CITY AIRPORT DEVELOPMENT PROGRAMME
(CADP1) S73 APPLICATION

DESIGN DEVELOPMENT REPORT

DECEMBER 2022

Figure 2.1.2: Proposed Forecourt Layout

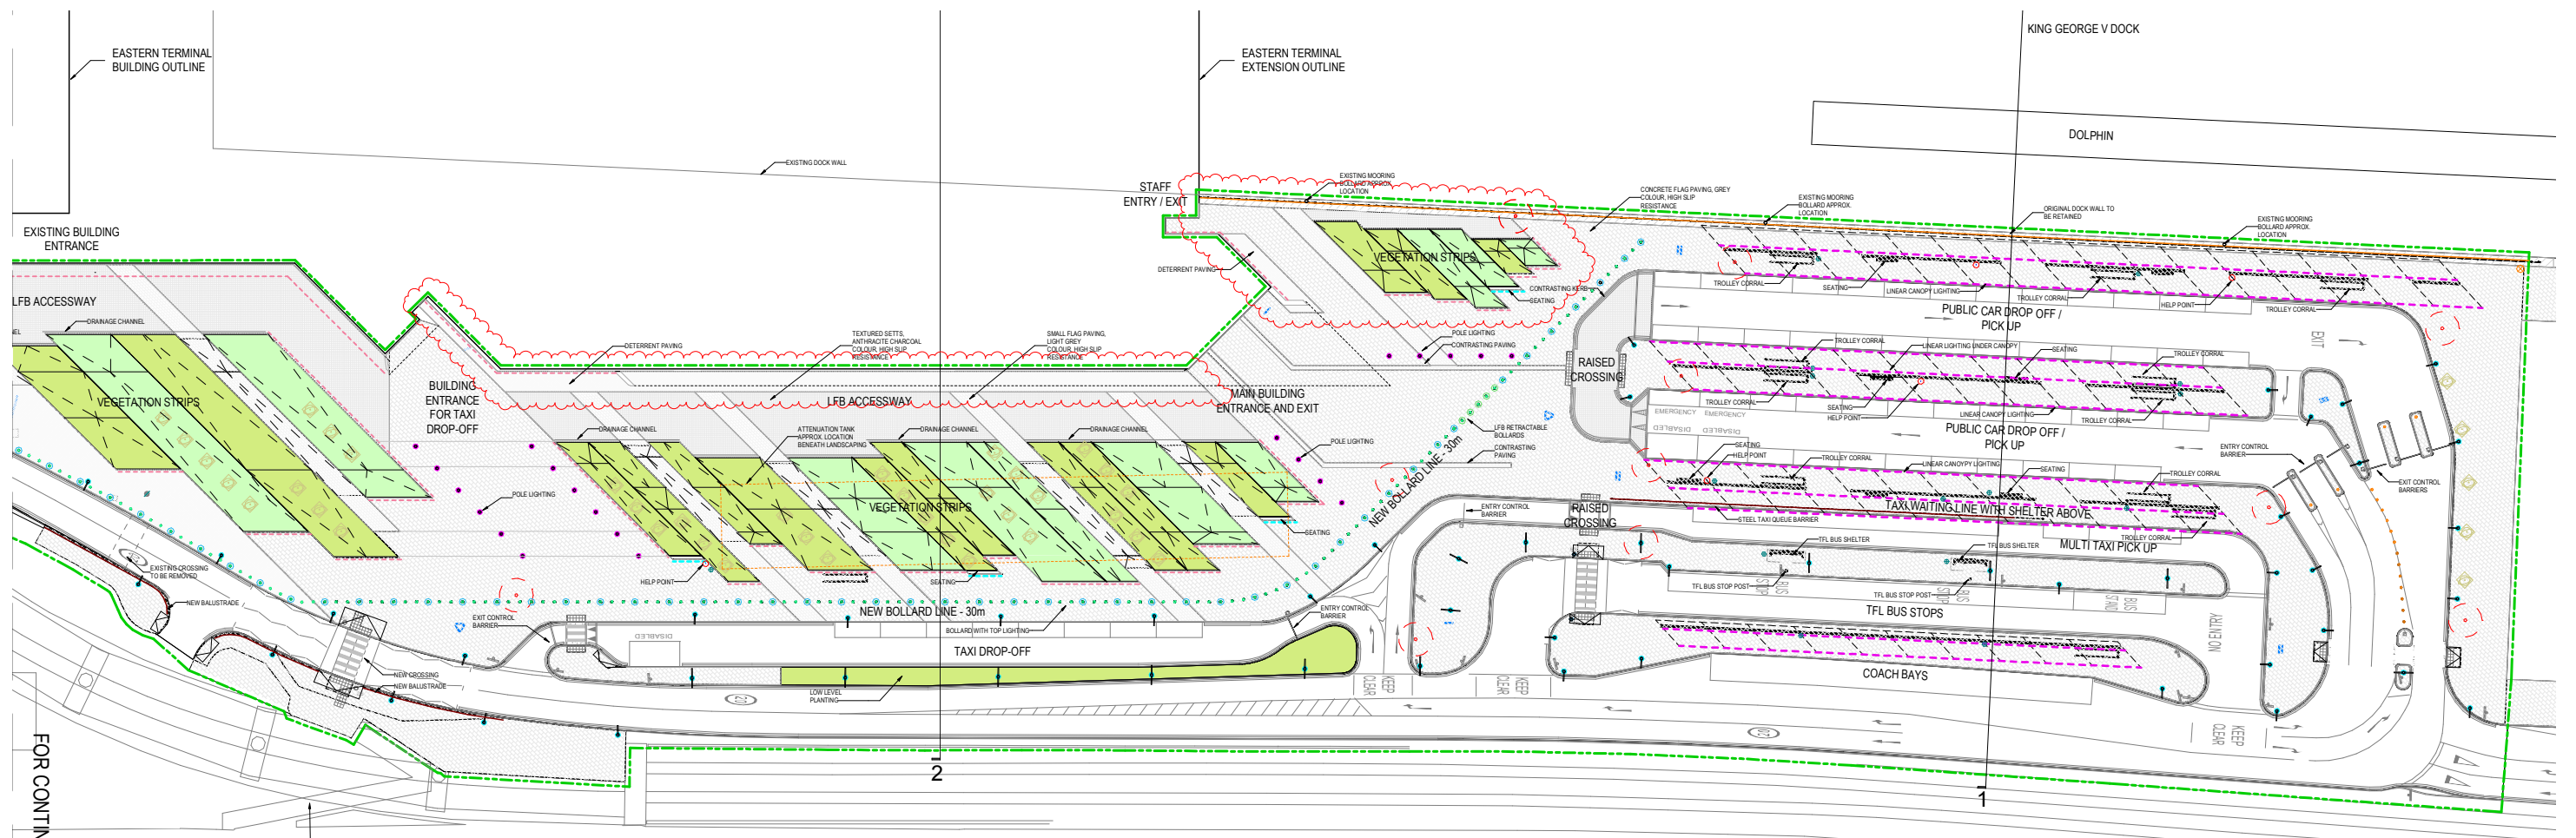
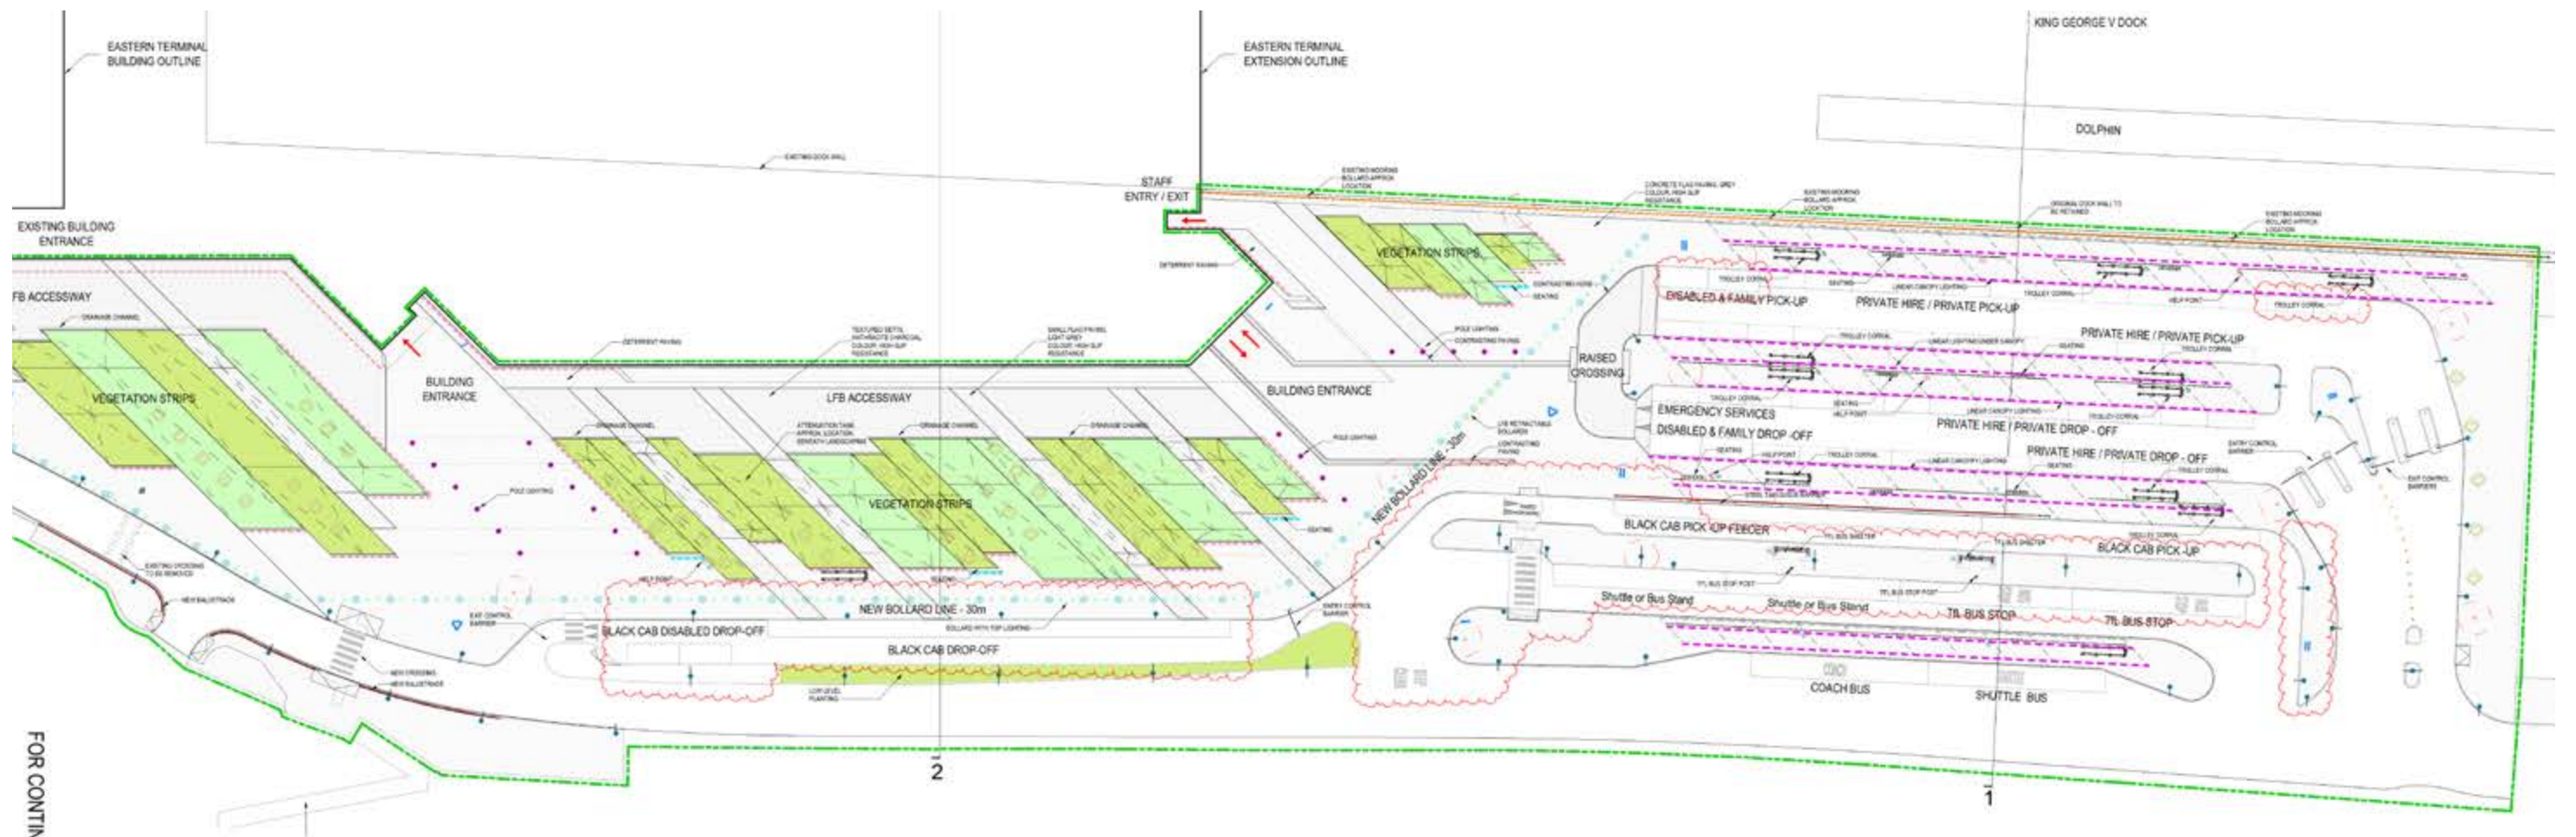
The consented Forecourt design (refer to *Figure 2.1.1*) has undergone minor improvements to accommodate the revised passenger demand of up to 9mppa and to reflect developments in the transport modal split that have been identified in the most recent passenger surveys (refer to *Figure 2.1.2*). These improvements involve some realignment of kerb lines and paint markings to accommodate additional public forecourt drop-off and black cab pick-up and drop-off. The bussing area has been slightly reconfigured to provide additional bays that safeguard for potential shuttle buses. The overall layout remains broadly the same as the consented scheme.

The update Forecourt design was tabled with TfL on 16 June 2022 and discussed in detail. In their formal response to the discussion, TfL highlighted the desire for bus routes to each have a dedicated stop as well as room for a bus stand. The proposal incorporates these requests, with capacity for the three local bus stands.

Figure 2.3.1: First Level plan illustrating the proposed bridge to the Temporary Coaching Facility.

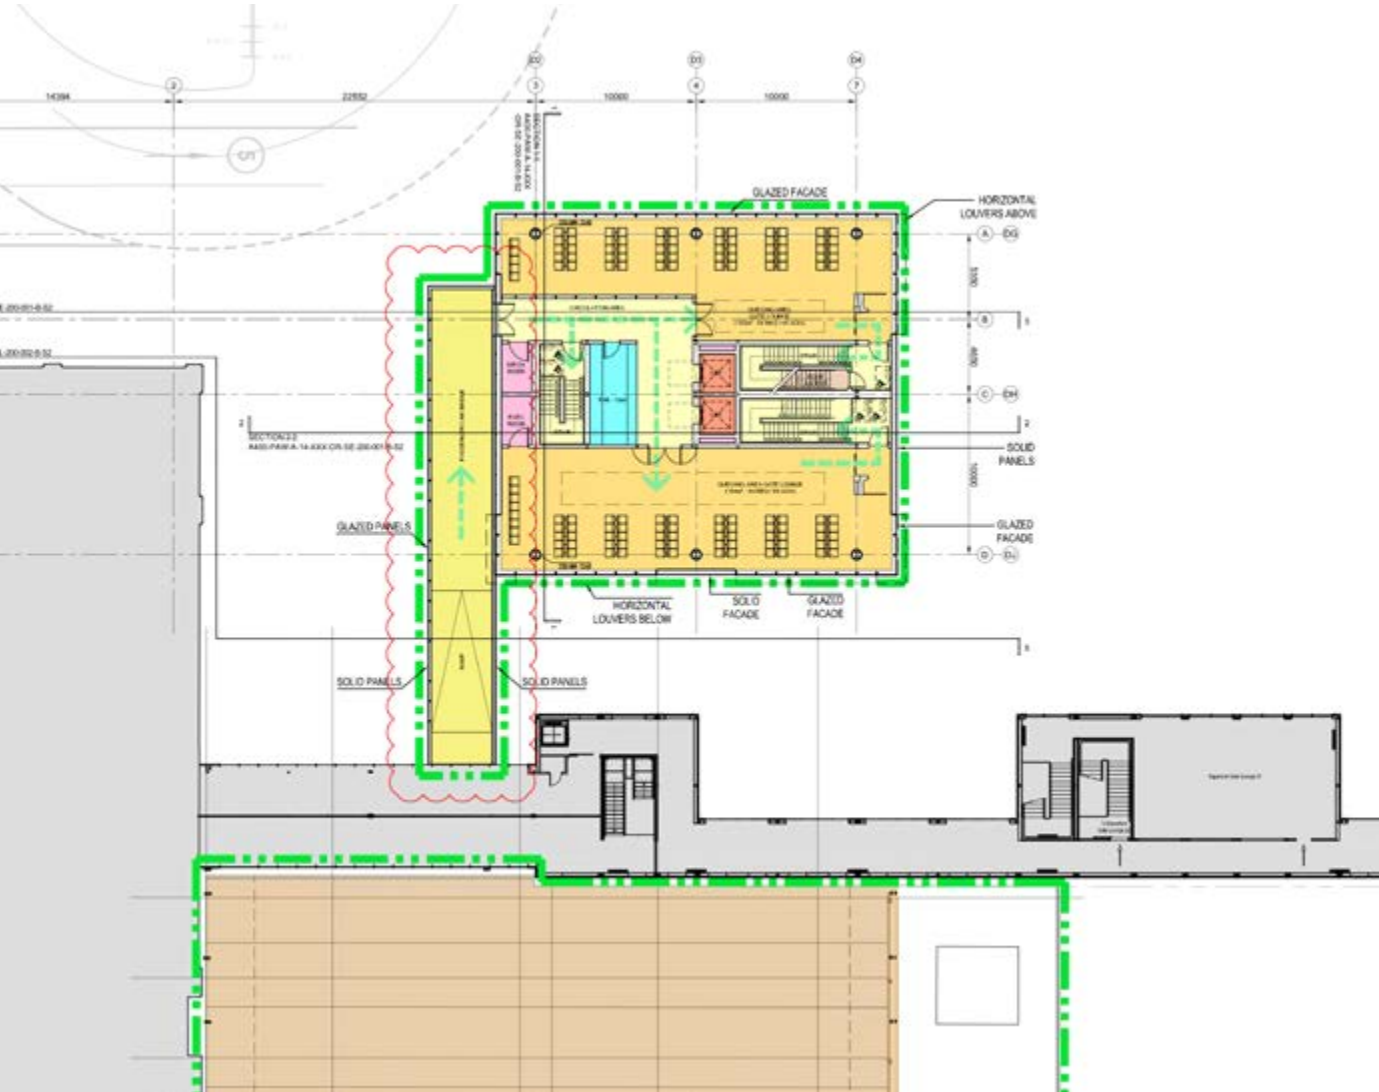
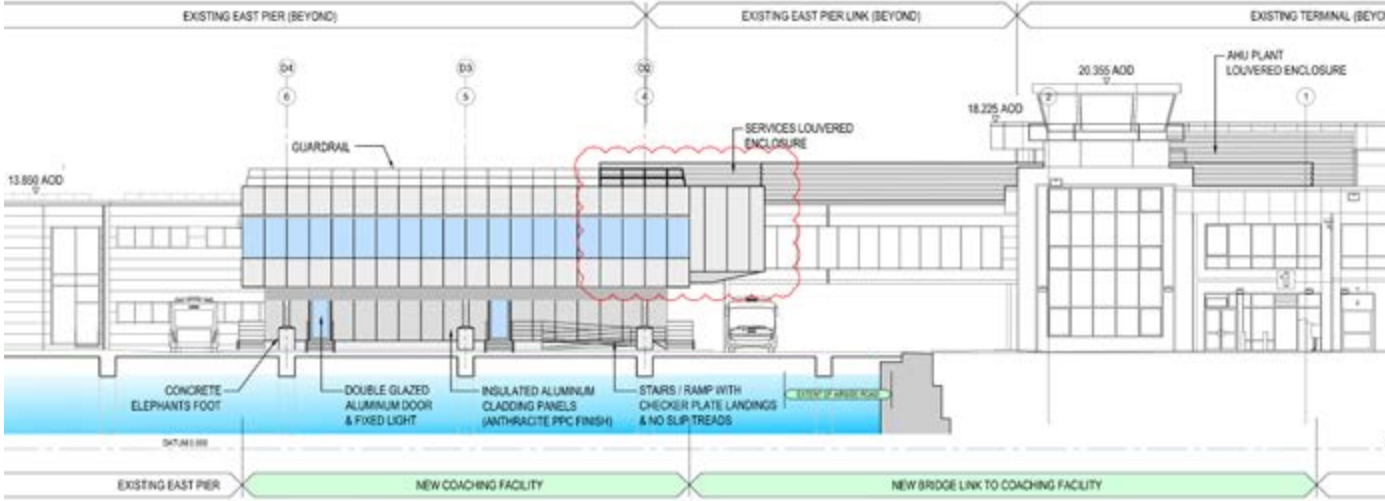
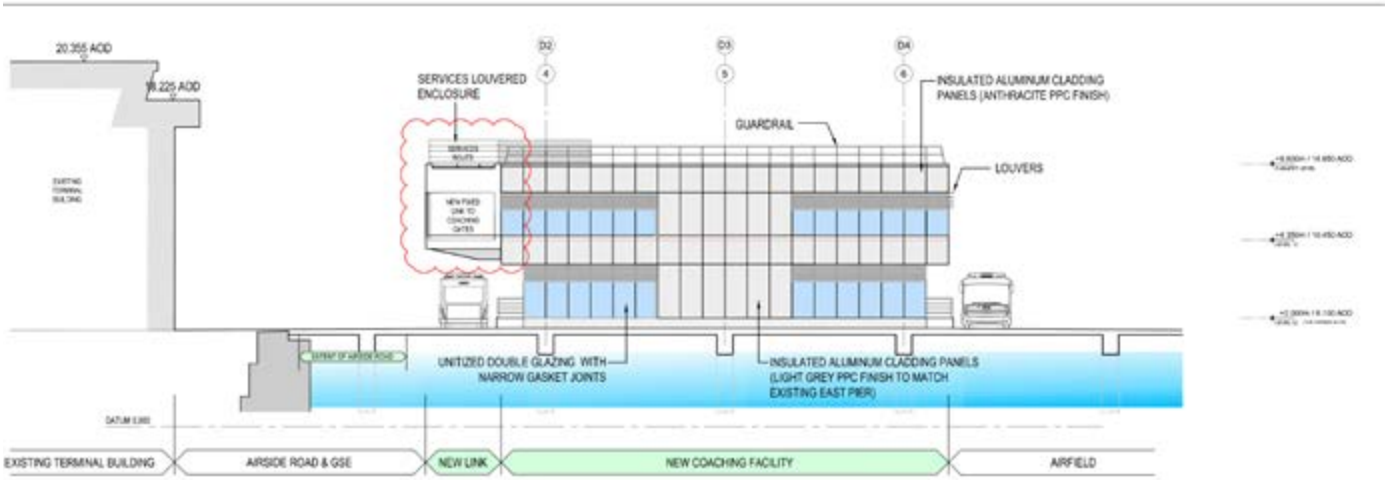
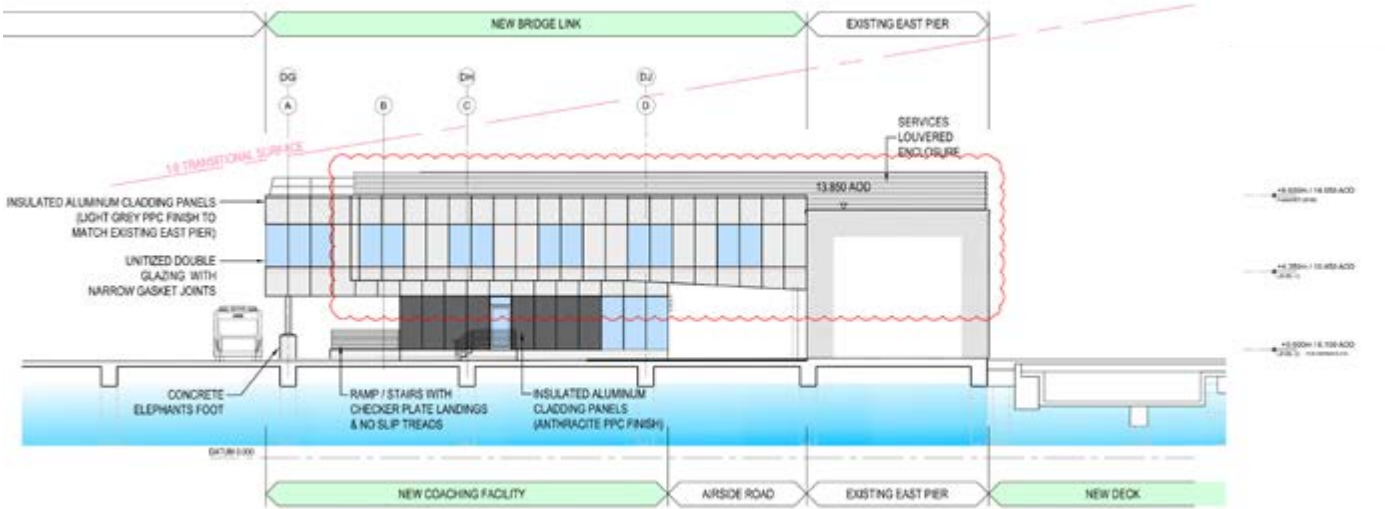
Some minor changes are proposed to the access of the coaching facility to allow for the presence of a Temporary Outbound Baggage (TOBB) facility built on stands 1 and 2 which was erected under Permitted Development Rights and is subject to the separate application for retention until the CADP1 works are complete.

The Coaching Facility was accessed via a link bridge at the first level of the Main Terminal Building (MTB) that facilitated the movement of departing passengers from the first level terminal airside lounge to the additional gaterrooms provided in the new temporary facility. Since this was proposed the TOBB has been erected. Baggage is conveyed to the new TOBB through an enclosed conveyor system that rises to the first level of the Terminal and blocks the proposed connection point for the link bridge that connects from the first level of the Existing East Pier (EEP) bridge to the Temporary Coaching Facility on stand 21. A new location has been proposed for the link bridge and is illustrated in the adjacent Figure 2.3.1.

The proposed bridge location is only visible from the airside terminal lounge and airfield apron areas and is very similar to the consented scheme link bridge in scale and appearance.

Figure 2.4.1: (Plan P4 Rev.A) Site plan showing location of stands for scheduled aircraft movements in yellow, with the buffer stand shown to the far left of the illustration as highlighted in dashed red.

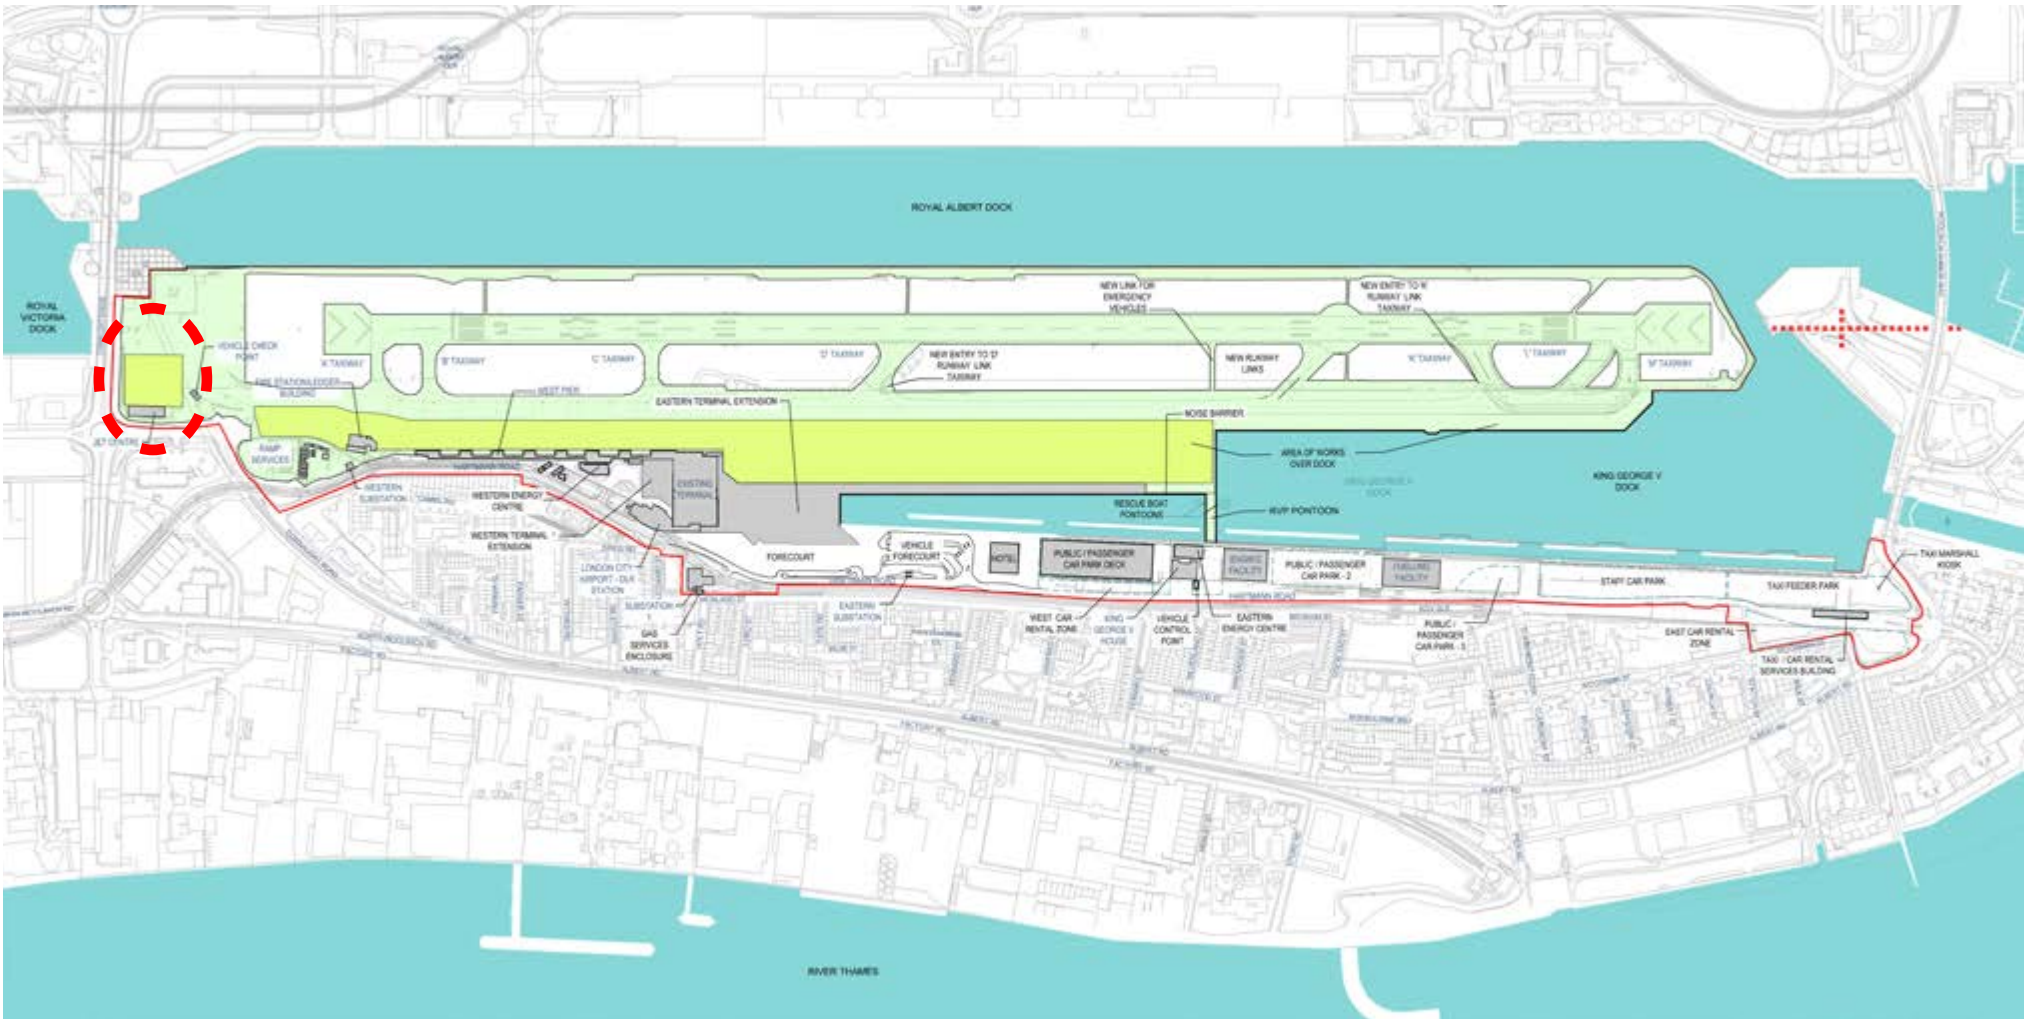
As can be seen from need case accompanying the application, there will be a need for more stands for larger Code C aircraft than the 8 currently available. In the first instance, this requirement will be met through bringing into use the 4 additional stands (29-32) on the remainder of the already constructed East Apron area. When the peak requirement for more than 11 larger Code C aircraft is reached at c.7.6 mppa, this may require some minor re configuration of existing apron areas, making more efficient use of existing apron areas particularly in the west, to allow more larger Code C aircraft to be accommodated. This could be achieved through a combination of:

- Re configuration of the East Apron to nose-in parking, allowing additional larger Code C aircraft to be accommodated;
- Additional flexibility to park Code C aircraft on the existing Jet Centre Apron; and/or
- Adjustments to the existing stand layout at the western end of the Main Apron.

These re configuration works would not require any increase in the permissible number of aircraft stands (25) in the CADP1 permission or additional apron area.

Please refer to *Figure 2.4.1 (Plan P4 Rev.A)* with the relevant stand areas shown in yellow fill. The buffer stand is shown to the far left of the illustration (as highlighted in dashed red) at the site of the Airport's existing Jet Centre. The proposed change will require an amendment to Plan P4 referred to under CADP1 condition 12.
